Materials RSI**RSI-1:**

Provide supplemental information on the HSM-MX Transfer Cask Adapter described in Updated Final Safety Analysis Report (UFSAR) section B.1.2.2 including: (1) drawing of the components with dimensions and tolerances, (2) a parts list with material specifications and quality category information, and (3) material and design limits information relevant to UFSAR Section B.4.2.

Figure OBS-C1-1: 61BTH Type 2 DSC Vent and Siphon Block

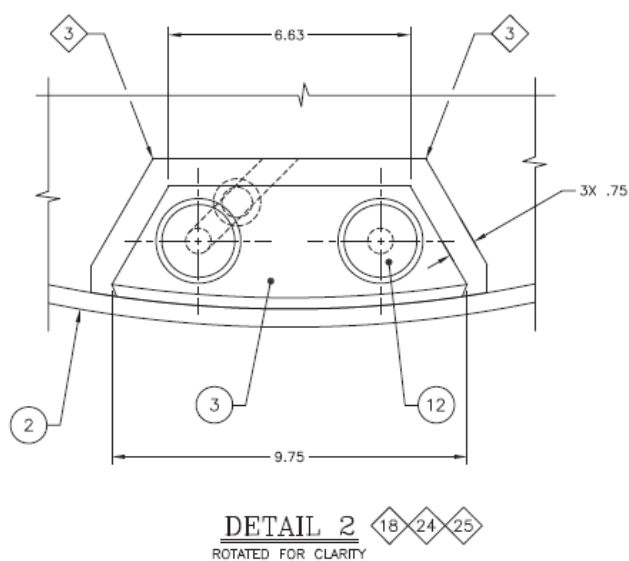
Ensure that the description of the siphon/vent port block welds for the EOS-37PTH/89BTH DSCs and the 618TH Type 2 DSC (Enclosure 4 to E-53778: Proposed Technical Specifications, CoC 1042 Amendment 2, Rev. 0) is appropriate.

In Enclosure 4 to E-53778, the description of the welds (first paragraph for NB-4243 and NB-5230, page 4-6) for the EOS-37PTH and the EOS-89BTH DSCs should be identical to the description for the 61 BTH Type 2 DSC (page 4-8); however, it's noted that the description for the 618TH Type 2 DSC also describes the siphon and the vent port block welds, whereas the description for the EOS-37PTH and the EOS-89BTH DSCs does not. The applicant should review the design drawings and ensure that the description of the siphon/vent port block welds is appropriate for both the EOS-37PTH/89-BTH DSCs and the 618TH Type 2 DSC.

The vent and siphon block exists as a component only in the 61BTH Type 2 DSC. In the 61BTH Type 2 DSC, the vent and siphon block is a trapezoidal steel block welded to the inside of the DSC shell, into which are drilled the siphon and vent ports, as shown in Figure OBS-C1-1. The vent and siphon block welds connect the block to the DSC shell and are partial penetration welds subject to the same examination requirements as the other discussed welds. Editorial corrections were made for clarity in Technical Specifications (TS) Section 4.0, Table "61BTH Type 2 DSC ASME Code Alternatives for the Confinement Boundary," ASME Code Section NB-4243 and NB-5230 (page 4-8).
